UNITED STATES PATENT AND TRADEMARK OFFICE

APPLICATION NO.	FILING DATE	FIRST NAMED INVENTOR	ATTORNEY DOCKET NO.	CONFIRMATION NO.
10/817,613	04/02/2004	Andreas Kimmerle	LORWER P28AUS	2469
20210	7590	10/13/2005	EXAMINER	
DAVIS & BUJOLD, P.L.L.C. FOURTH FLOOR 500 N. COMMERCIAL STREET MANCHESTER, NH 03101-1151			NGUYEN, JIMMY T	
			ART UNIT	PAPER NUMBER
			3725

Office Action Summary	Application No. 10/817,613	Applicant(s) KIMMERLE, ANDREAS	
	Examiner Jimmy T Nguyen	Art Unit 3725

DETAILED ACTION

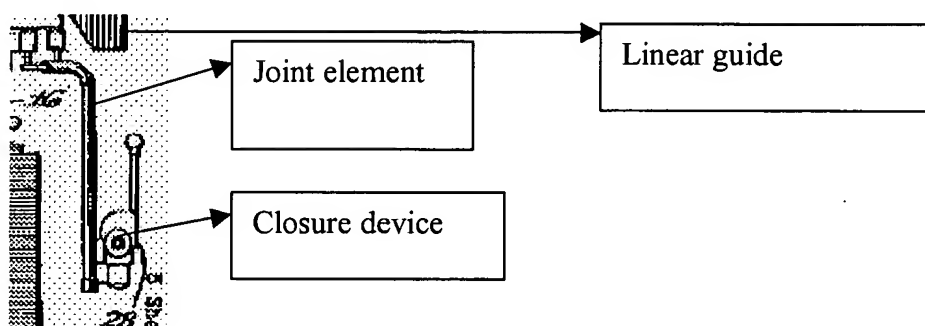
Regarding claim 22, the closure device is arranged such that the closure device (28) can move (see col. 3, lines 13-16) on the linear guide by a joint element (see the illustration below).
